Bramford to Twinstead Reinforcement

**Document 8.9.5: Temporary and Permanent Access Technical Note –
Suffolk County Council**

**Final Issue A
January 2024**

Planning Inspectorate Reference: EN020002

Drawing title: **F-AP10: The Street, Assington
 Proposed Visibility Splay
 Concept Design
 Sheet 1 of 1**

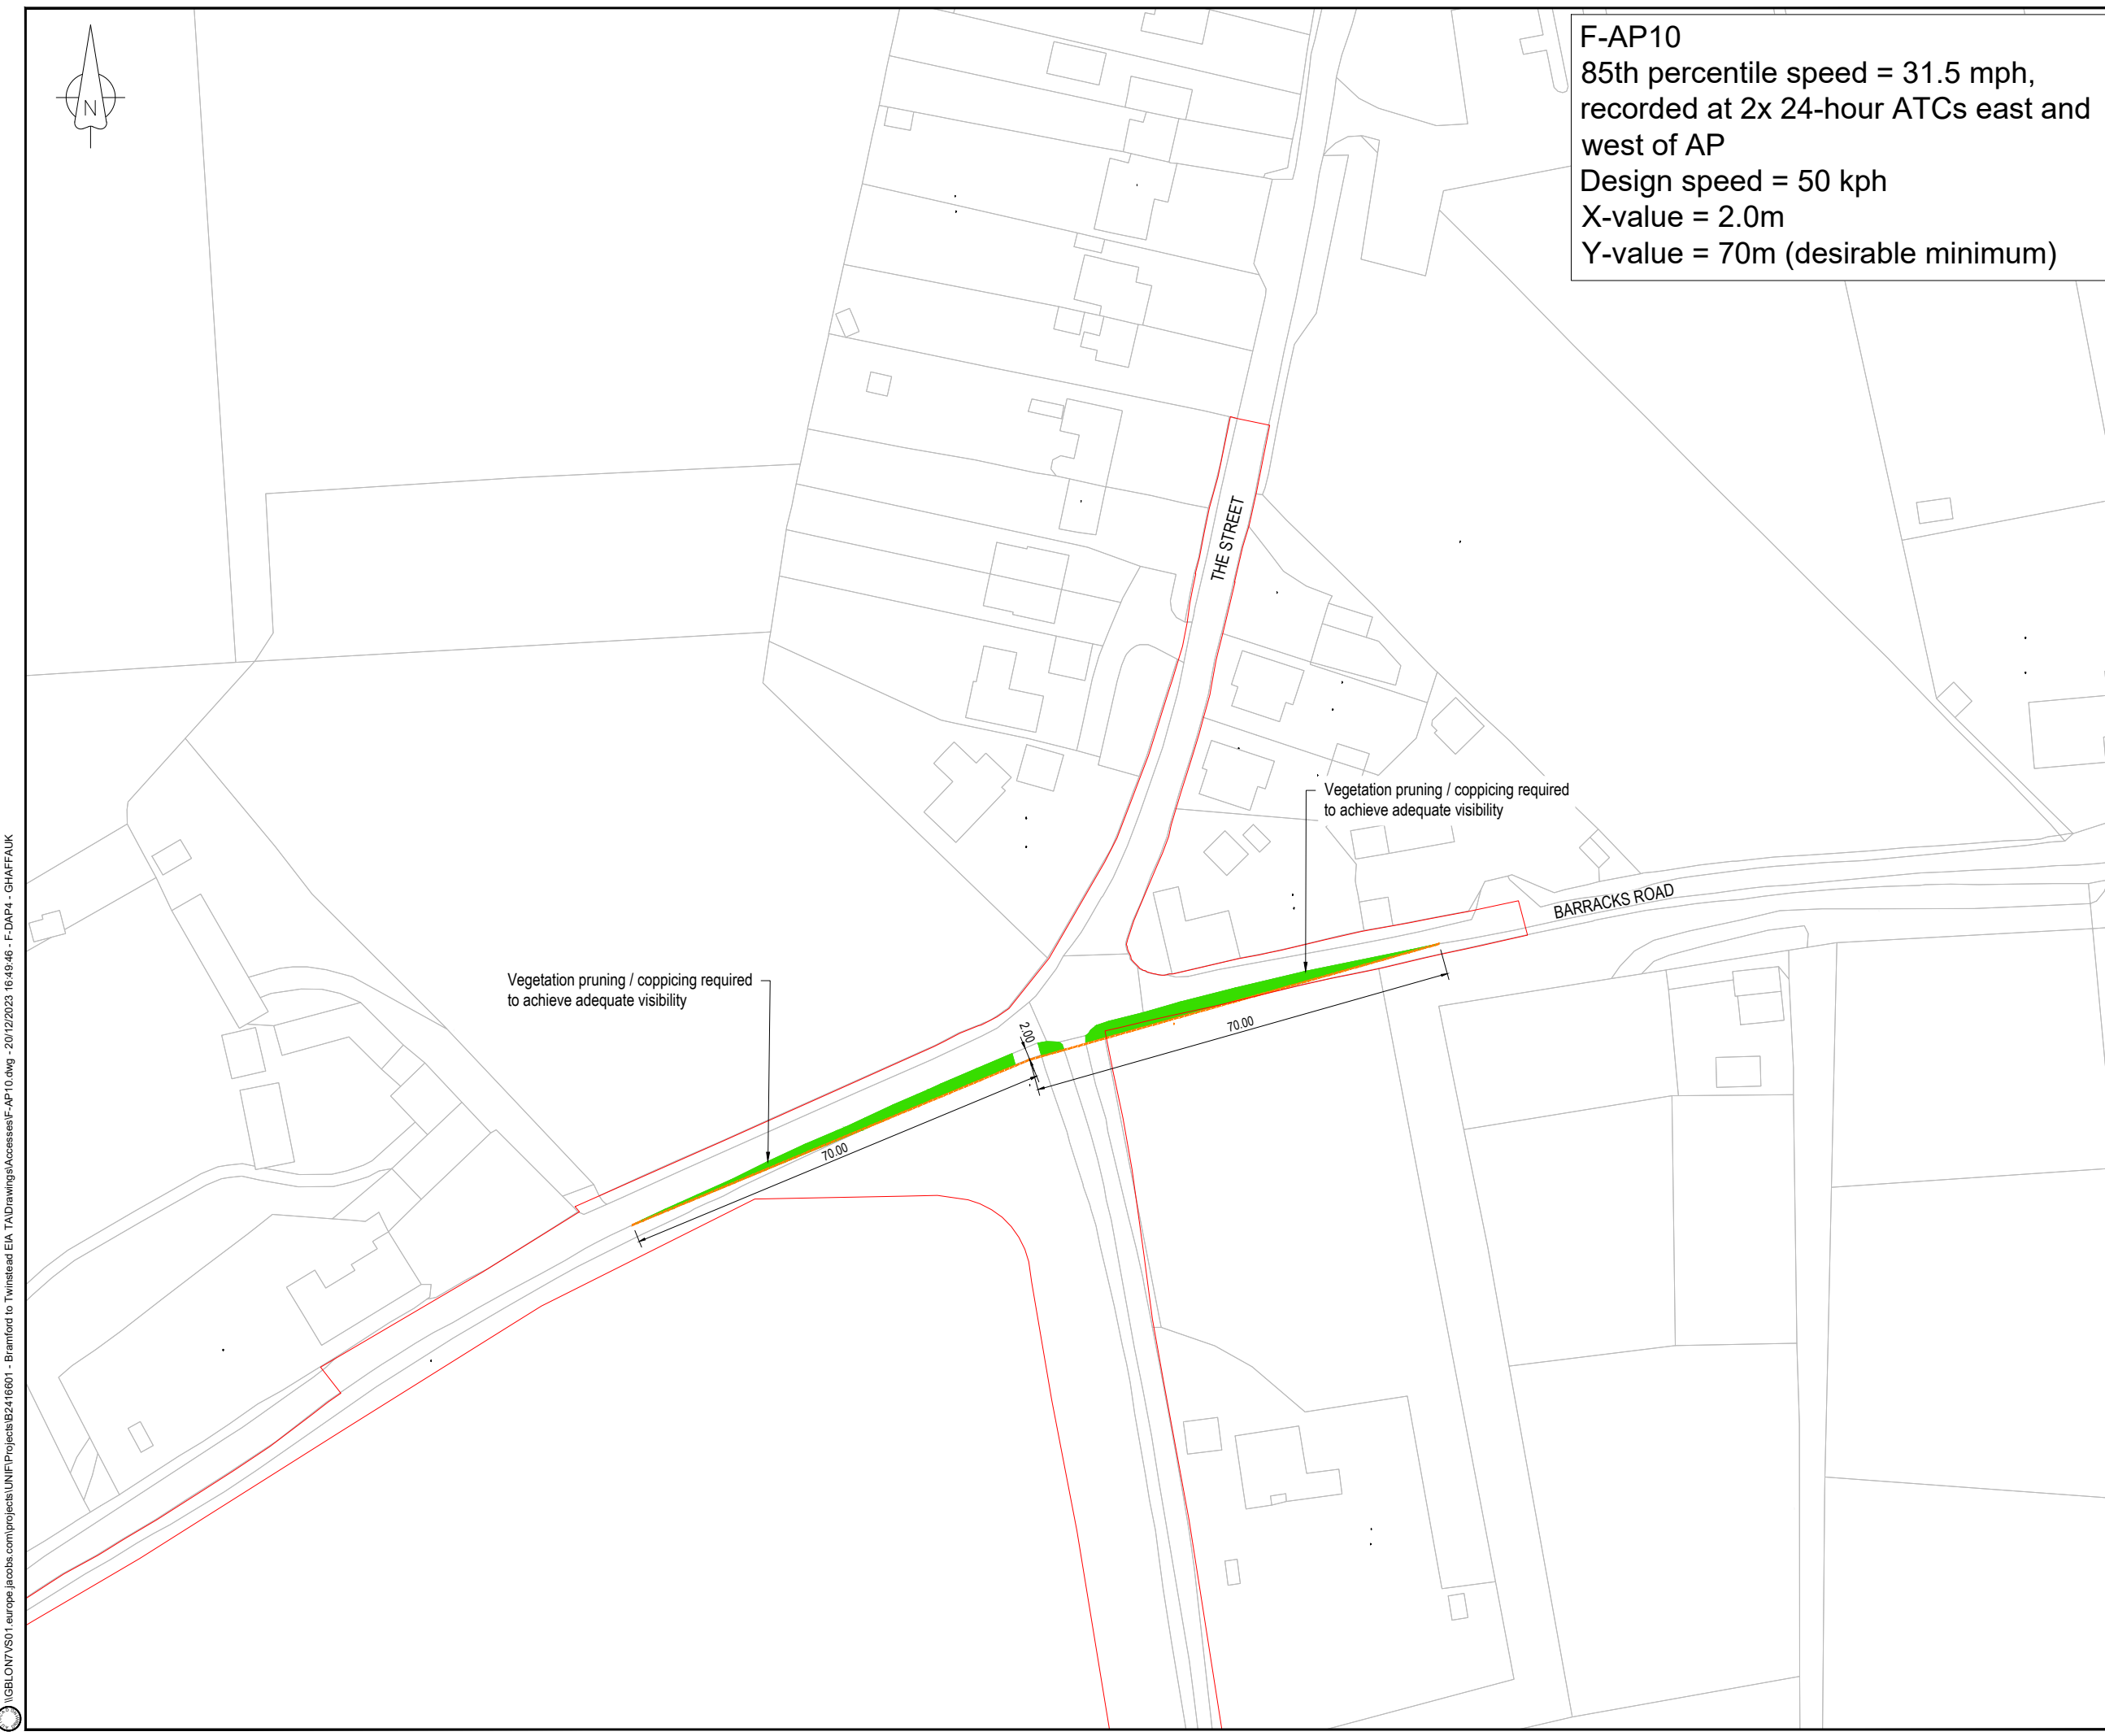
2.8.5 In initial discussion with SCC, it was noted that:

- The side road of Barracks Road is approaching a give way line so design speed might reasonably be much lower than that assumed based on nearest free-flow survey locations; and
- Signs and salt bin locations are likely to be back of highway, which might mean highway boundary is not where it might have been assumed to be. Salt bins may be parish owned and not in public highway.

The combination of these aspects means that a lesser visibility splay on the east side may be appropriate, meaning that an appropriate visibility splay can be achieved with no activity outside the highway boundary and/or Order Limits. In addition, a banksman could stand in a position outside the field access where they can see along all three arms of the junction and direct a works driver when it is safe to exit. This type of managed access provides an additional level of provision should it be needed. The banksman would not direct any vehicles except works vehicles. Both options offer potential solutions to delivery of the access in this location.

Drawing title: **F-DAP4: The Street, Assington
 Proposed Visibility Splay
 Concept Design
 Sheet 1 of 1**

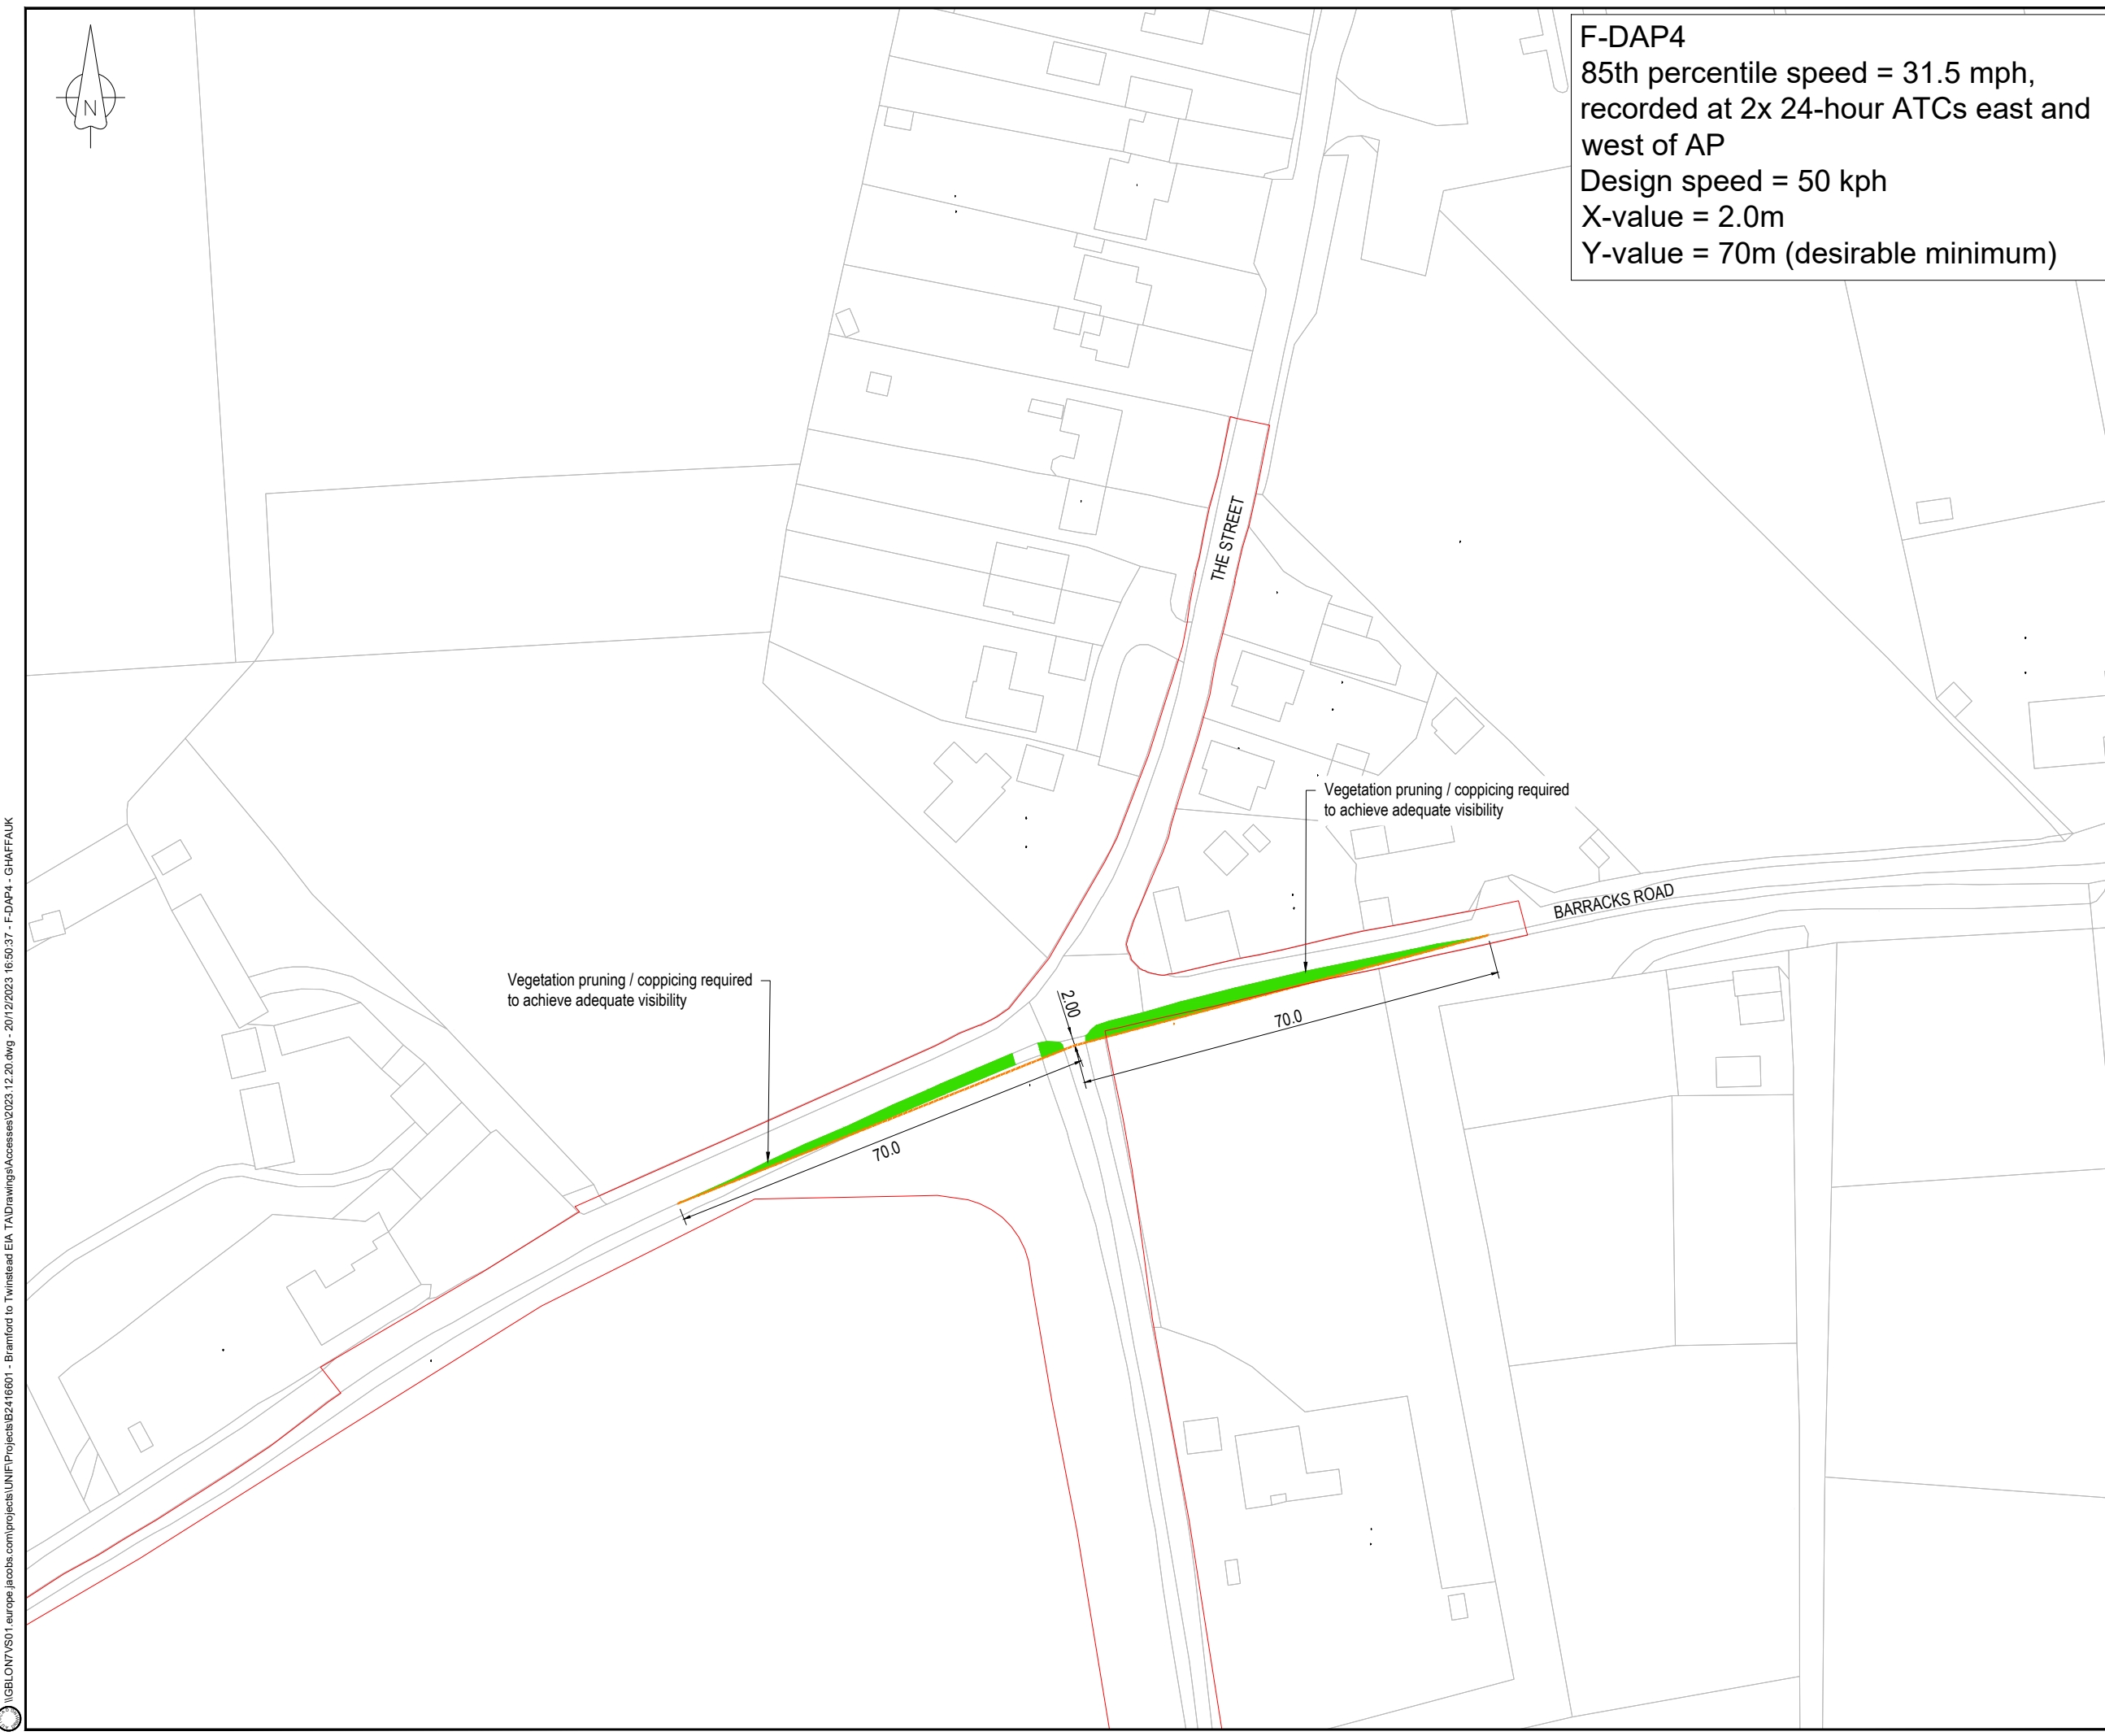
- 2.9.5 In initial discussion with SCC, it was noted that, similar to the adjacent field access described for F-AP10 above:
- The access road boundary with public highway (formed from a bullnose dropped kerb across the access) is a little further forward than the OS data suggests;

- The side road of Barracks Road (the road to the right for drivers leaving the access) is approaching a give way line so design speed might reasonably be much lower than that assumed; and

- Signs and salt bin locations are likely to be positioned to be at the back of highway, which might mean highway boundary is not where it might have been assumed to be.

- 2.9.6 The combination of these aspects means that a lesser visibility splay on the east side may be appropriate, meaning that no activity outside the highway boundary.

- 2.9.7 The major road of this junction is subject to a 20mph limit and has a bend in the area of the junction with Barracks Road but is busy and with speeds that members of the team discussing the access considered likely to be above the posted limit. It would be possible for a banksman to stand in a position outside the access road and direct a works driver when it is safe to exit. This type of managed access provides an additional level of provision should it be needed. The Applicant is therefore of the view that solutions are available for the delivery of this access.
